Plan Commission

Agenda

Monday, July 27, 2020

SUBJECT: Staff recommendation and possible action regarding a site plan request for a new pet day care facility at 2140 American BL (Parcel WD-L179-8).

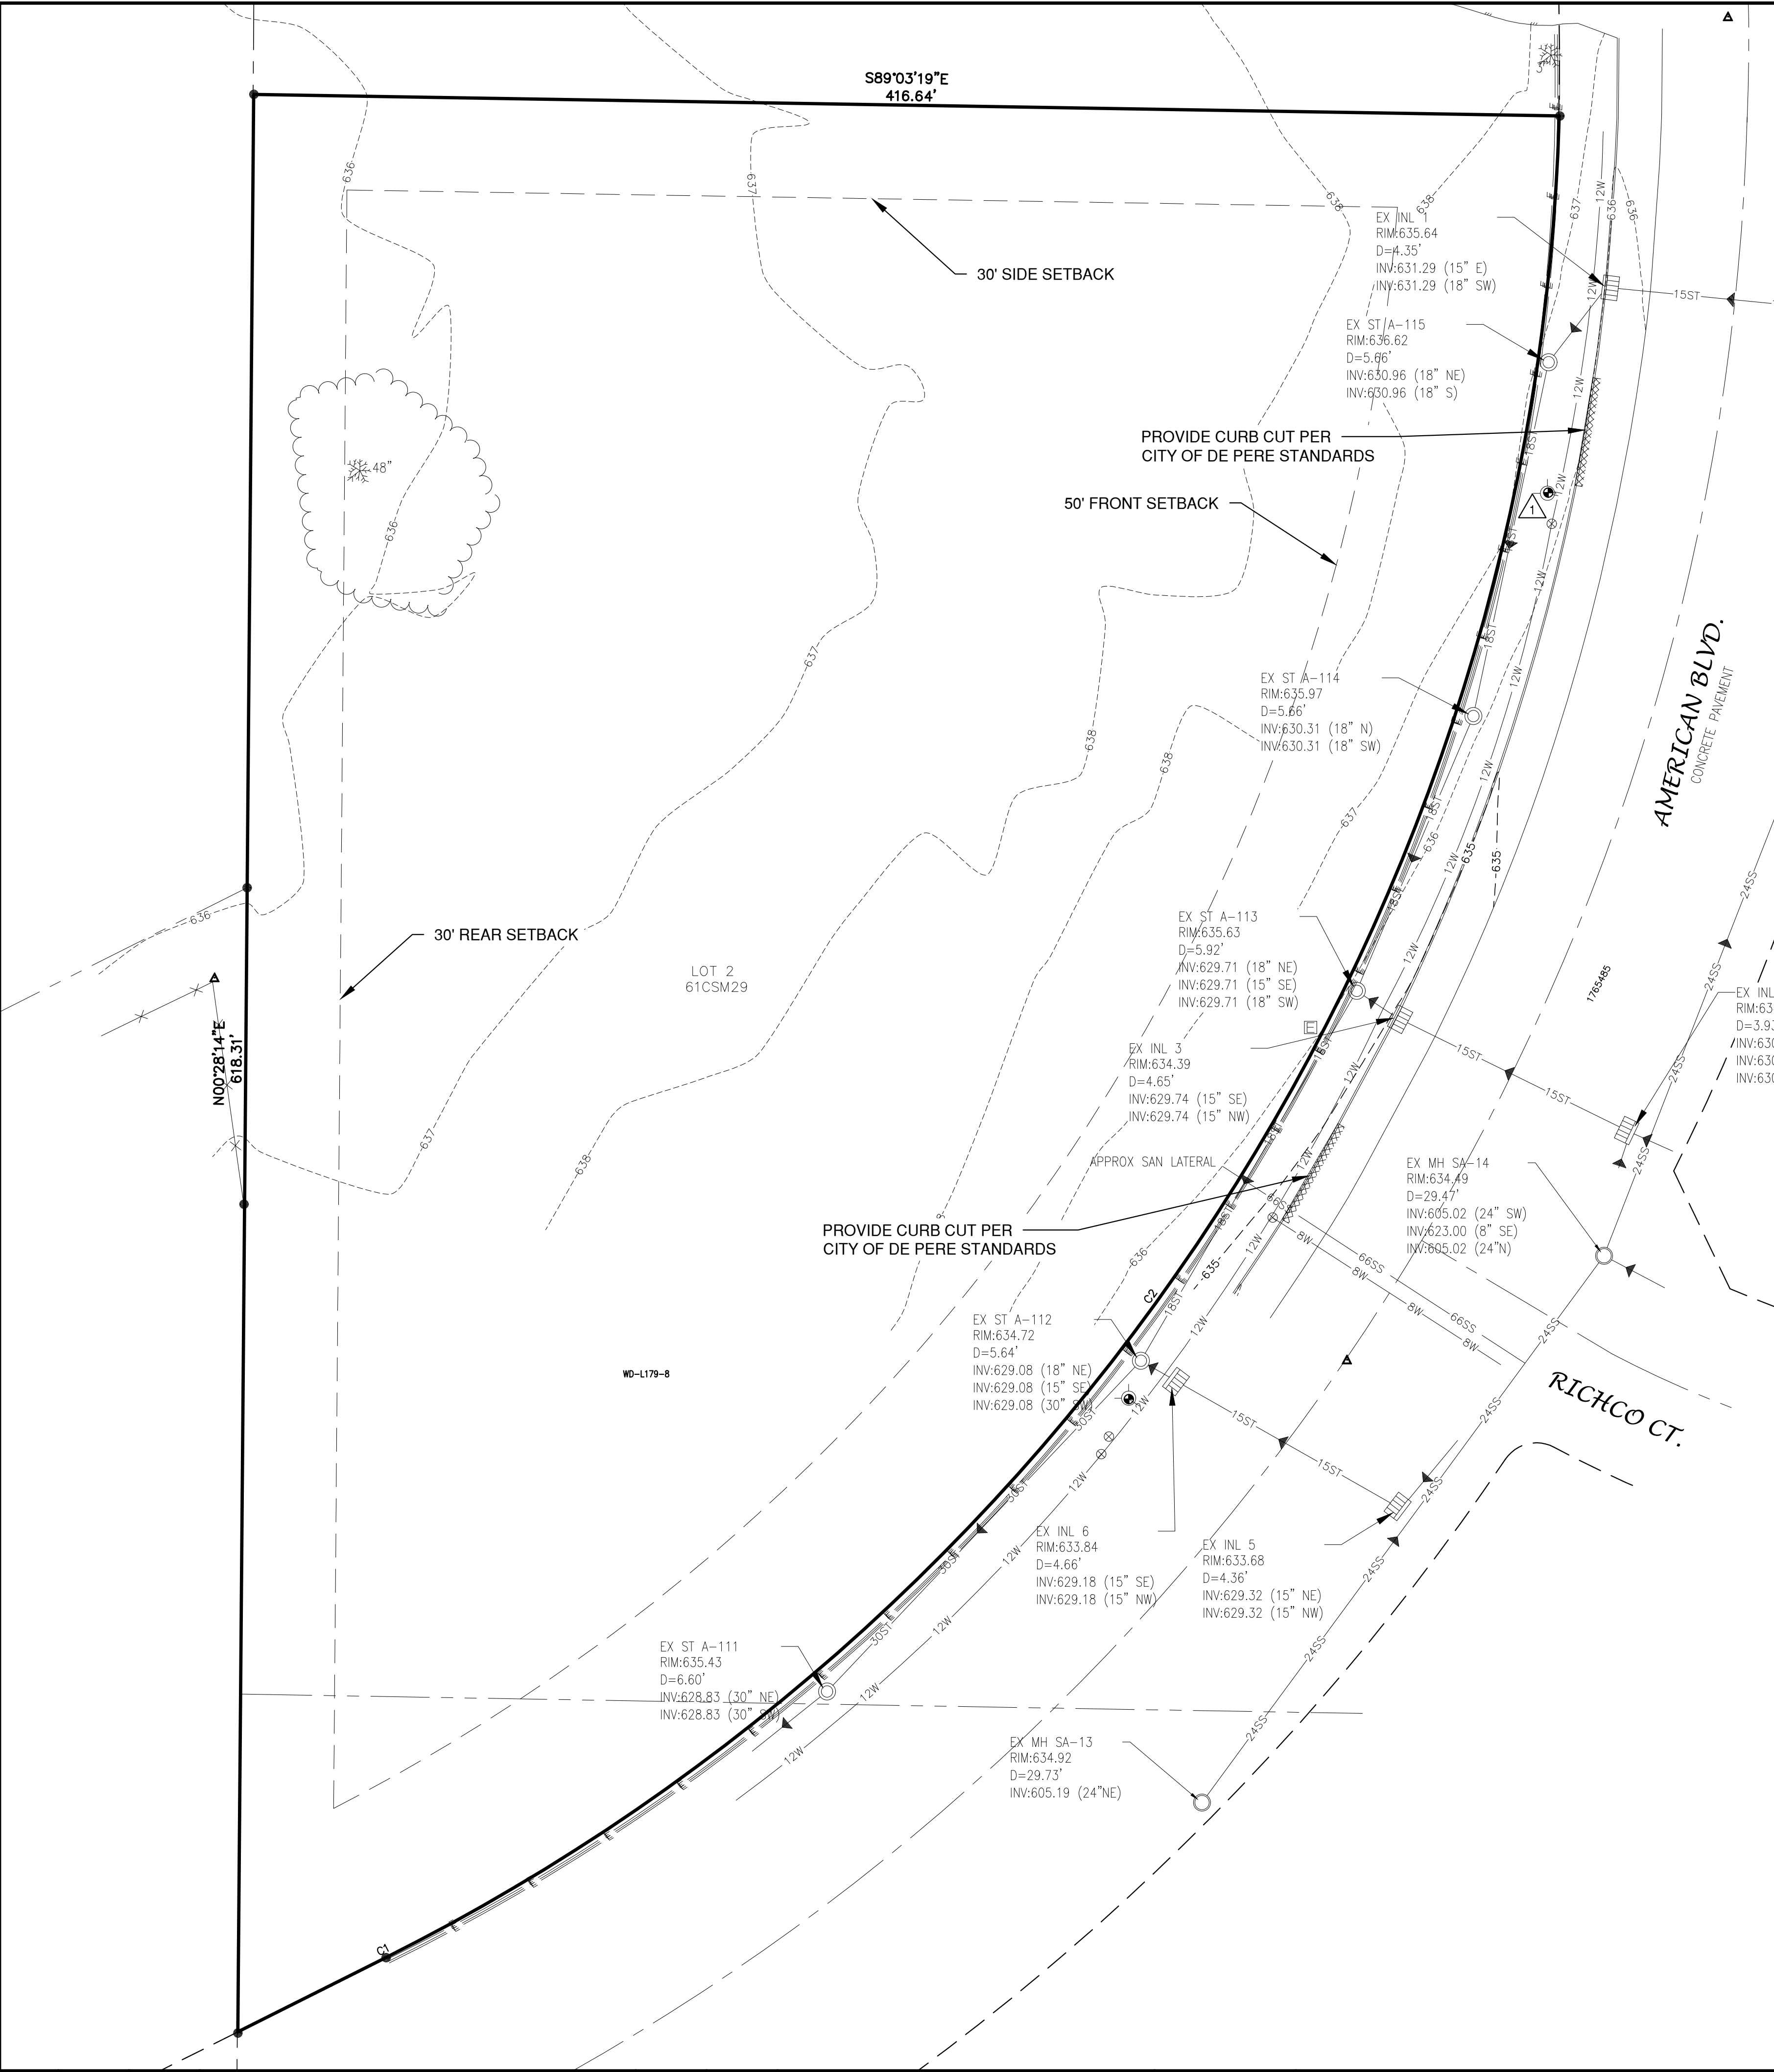
3. Sheet 2: Include pavement markings and/or signage at northern driveway to indicate it is right-in, right-out only.
4. Sheet 2: Update curb cut notes to be the following: "Provide hydraulic, profile curb cut per City of De Pere Standards."

5. Sheet 2: Specify 4-inch wide pavement marking.
6. Sheet 3: Add Note "6. 2-inch water tap to be coordinated with City of De Pere Water Department at 920-339-4063."

- c. Sheet 2: There is a 3 square foot difference in site area when all the areas are summed up and compared to the total area.
 - d. Sheet 2: Knox Box location is coordinated with the City, not Village.

- e. Sheet 2: Typo of "Enclosure" for trash enclosure.
 - f. Sheet 3: Identify the water meter size for the site.
 - g. Sheet 4: Eliminate duplicate erosion control notes. This is not the erosion control sheet.

EROSION CONTROL
INLET PROTECTION
TYPE D-HR AND TYPE D-M

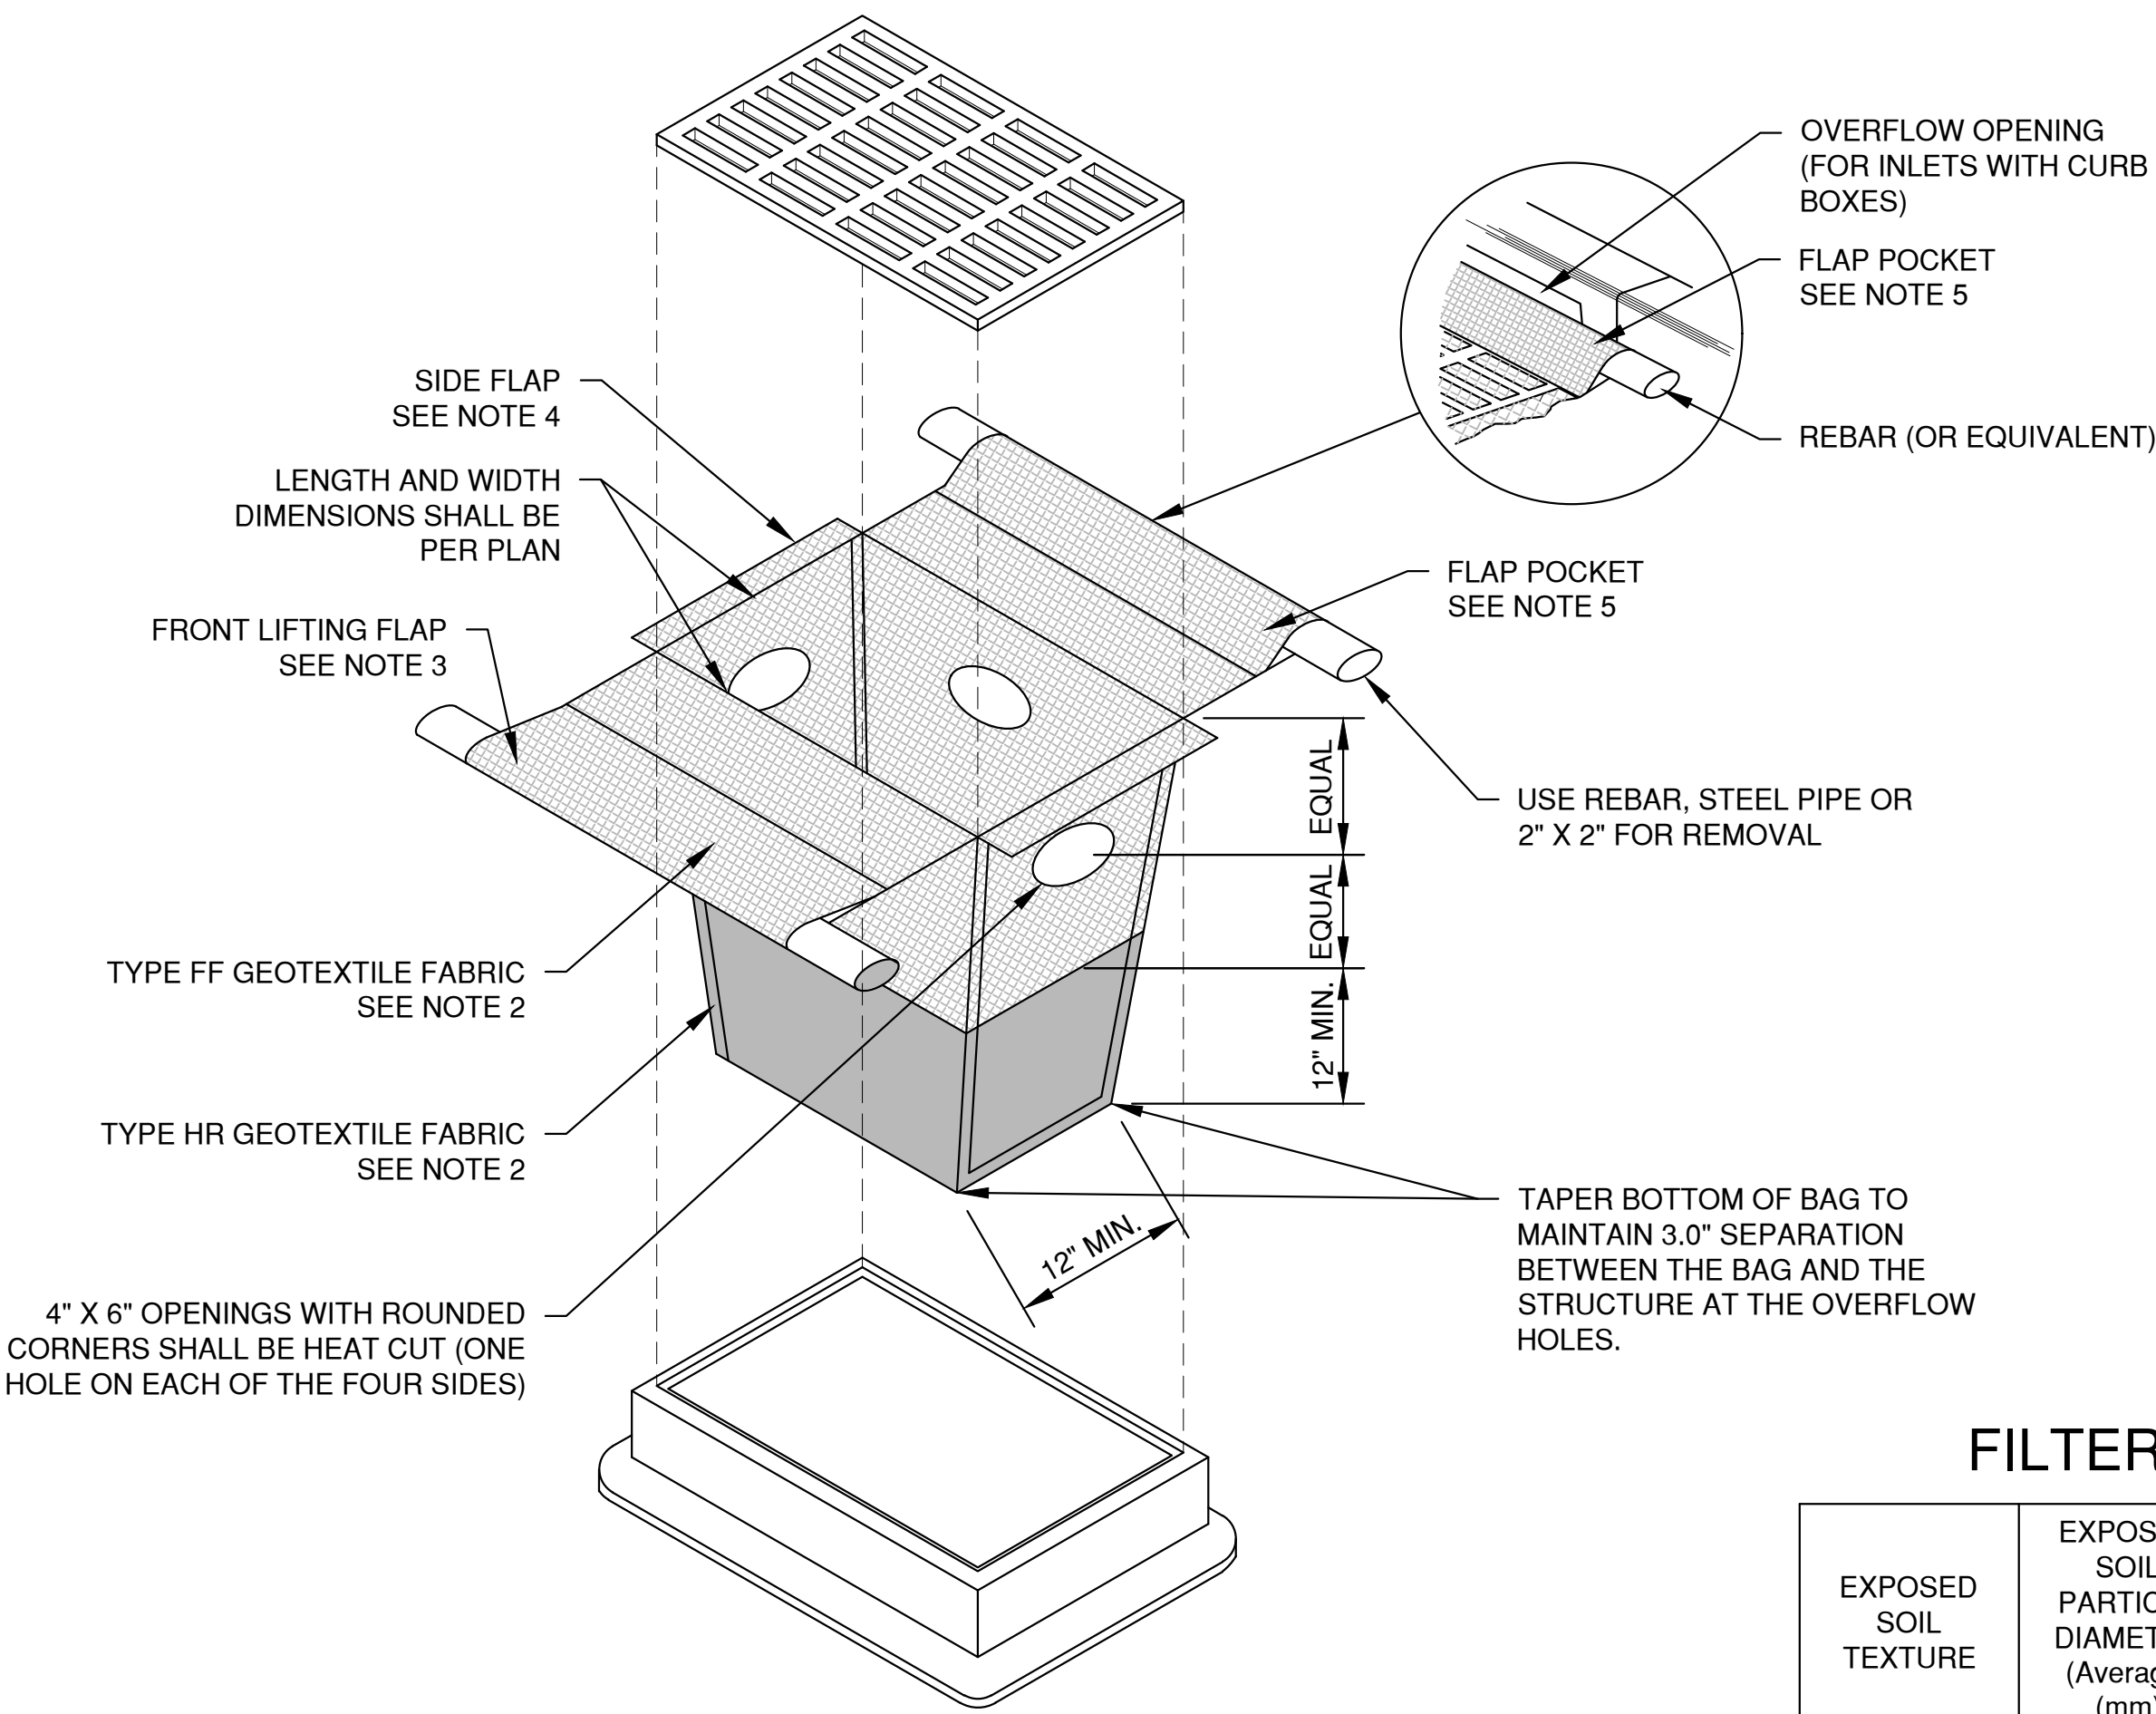
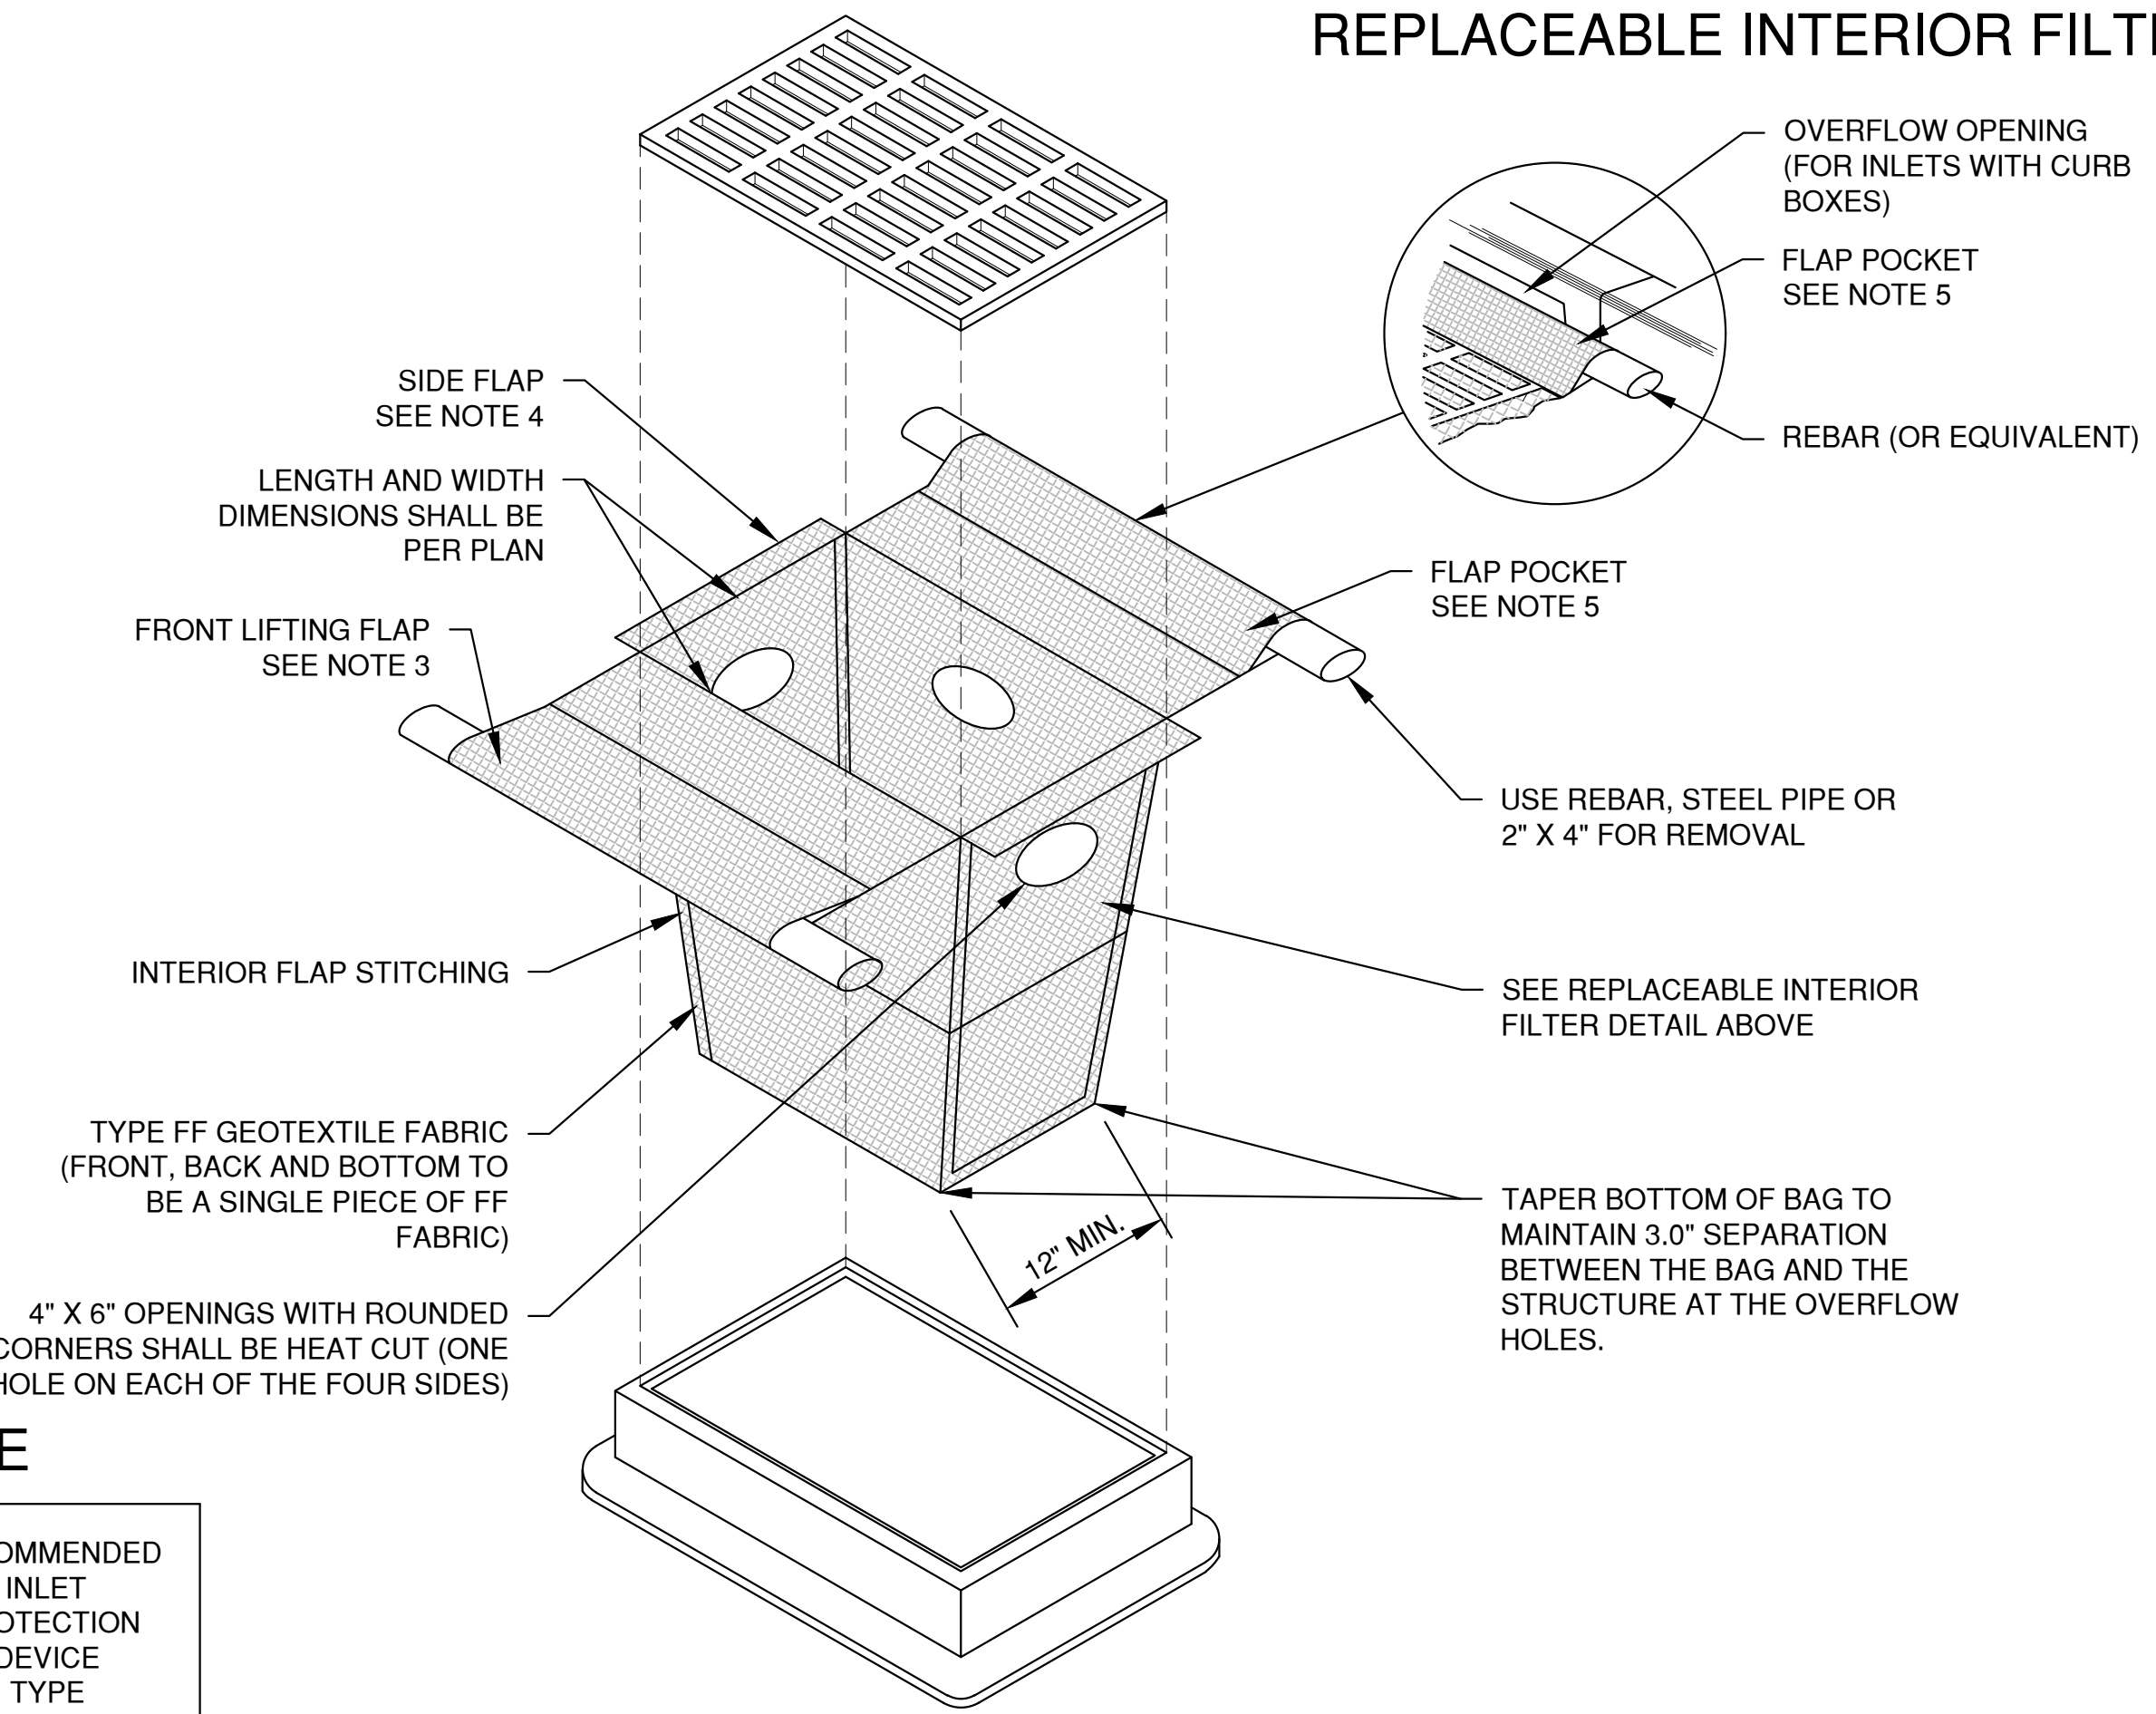
9. Sheet 5: Show stockpile location and protection around stockpiled materials.
10. Sheet 5: Inlet protection should be specified as TYPE D.
11. Sheet 5: Provide WisDNR soil loss sediment discharge calculations and corresponding map.
